# City of Santa Fe, New Mexico

# memo

**2025-011229-HDRB, 815 Dunlap St.,** Westside-Guadalupe Historic District, contributing, Christopher Purvis, agent for Michael Zimmer, owner, proposes to replace and repair windows, remove the greenhouse, and stucco. An exception is requested to 14-5.2(D)(5)(a) for replacing historic windows.

Figure 4: Window Schedule

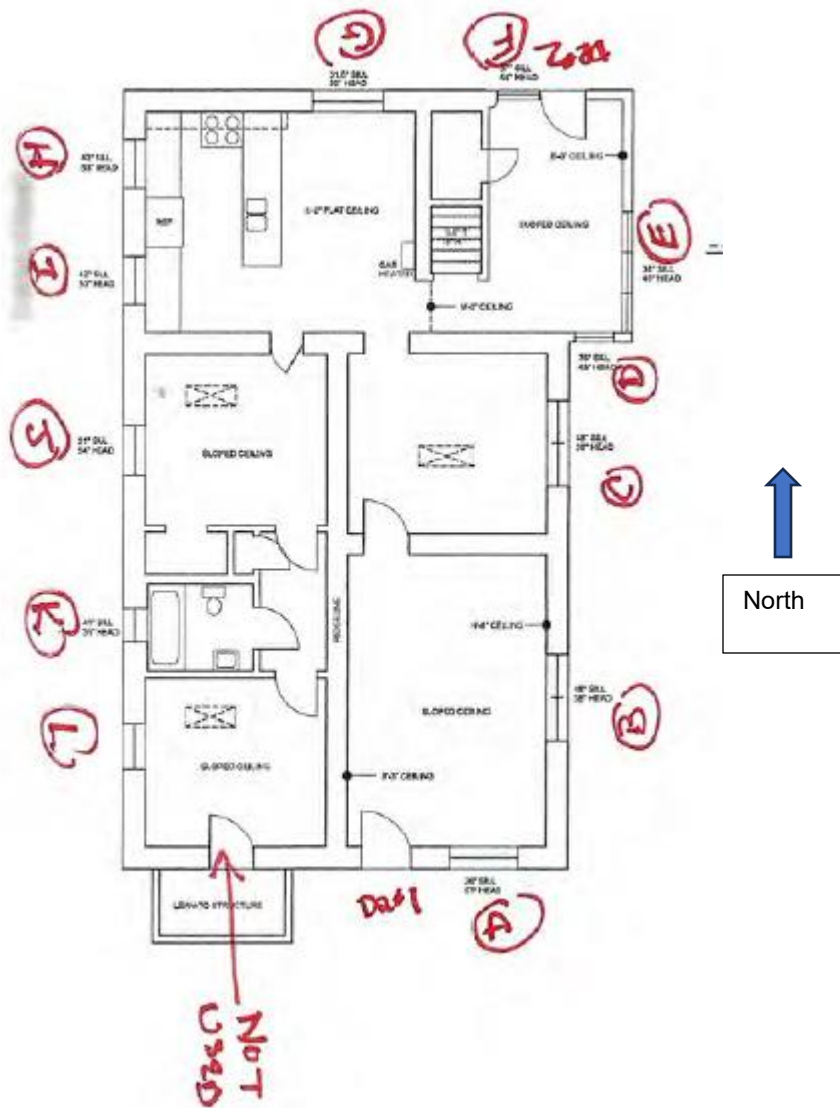
- 1) Replace windows and doors, including historic windows on the primary facades. The windows will be white K-Kron painted wood TDL insulated glass, with simulated divided lites in lite patterns to match the existing windows. An exception is requested to section 14-5.2(D)(5)(a) for replacing historic windows.
  - a. Window C is historic and restorable. The applicant proposes rehabilitating the window.
  - b. Windows G and K are non-historic and will be replaced.
  - c. The applicant and window assessment states that windows A, B, D, E, F, H, I, J, and L are historic but are beyond repair. The applicant requests that all these windows be replaced.

- 2) Remove the non-historic greenhouse structure on the primary façade
- 3) Reestablish the window on the left of the door of the south primary façade located behind the existing greenhouse, which is a non-historic door (located in Figure 4 as the door noted “not used”).
- 4) Stucco the residence using cementitious Buckskin.
- 5) Install ground-mounted HVAC.
- 6) Install a 48” high coyote fence on the north of the residence to screen the HVAC.

Staff Response: Staff finds that this criterion is met. The lite patterns of the replacement windows are proposed to match those of the original windows. The residence will appear the same with the new windows as with the existing ones; therefore, the character of the district will not be harmed.

Staff Response: Staff finds that this criterion is met. The window assessment shows that all except one window is beyond repair. This would cause hardship for anyone to reside in the residence.

Staff Response: Staff finds that this criterion is met. Replacing inoperable windows will ensure that the residence can be occupied. All except one window shows in the assessment as not being operable.
